UNITED STATES PATENT AND TRADEMARK OFFICE

APPLICATION NO.	FILING DATE	FIRST NAMED INVENTOR	ATTORNEY DOCKET NO.	CONFIRMATION NO.
09/914,231	09/14/2001	David John Fisher		1861

Office Action Summary

DETAILED ACTION

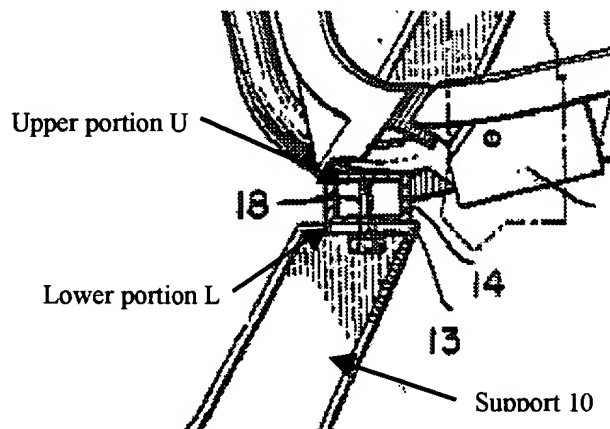
Hoven discloses an audience chair including at least one seat having a base (Figure 11) and a beam 14 supporting the seat and being connected to a surface behind and adjacent to the seat. The beam 14 has an upper portion "U" for receiving the base and a lower portion "L" for connecting to the support 10 (shown below) in an enlarged view of Figure 6. Furthermore, the connecting means, via a bolt 18, enables the seat to move longitudinally along the beam. Regarding claims 31 and 32, Figures 1 and 2 show a plurality of individual seats, unconnected from one another, located along the beam 14; thus, each chair having the capability to alter positions along the beam, relative to the other seats.

Figure 2
Exploded View of Hock

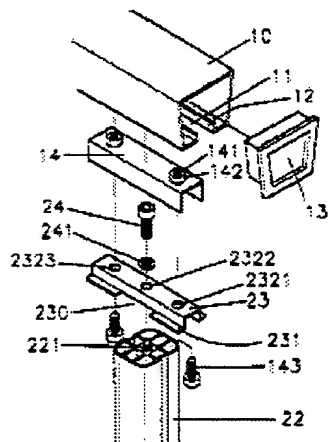
Hoven discloses a similar seat with at least one seat, a base and a beam having a support with connecting means. However, Hoven only teaches of a bolt 18 for connection means. Yet, Hock teaches of a longitudinal channel or slot 11 in the underside of the beam 10 for receiving a connector member 23 and bolt 24. The connector member 23 and 24 is connectable to the support 22 of Hock. It would have been obvious to one having ordinary skill in the art at the time the invention was made to modify the connection means of Hoven with a longitudinal channel and connector means, as taught by Hock, for a more secure and easier connection assembly.
